Amendments to the Drawings:

REMARKS / ARGUMENTS

ANNOTATED SHEET SHOWING CORRECTIONS 2/2

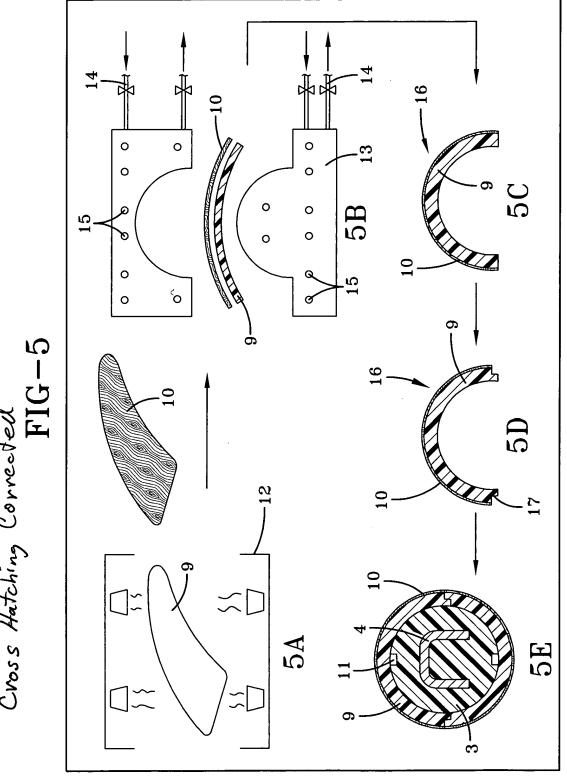
The examiner objected to the drawings. Corrected drawings have been prepared and are attached hereto in which the cross hatching has been corrected to indicate the same materials as the specification and claims. Accordingly withdrawal of this objection is respectfully requested.

Cross Hatching Corrected
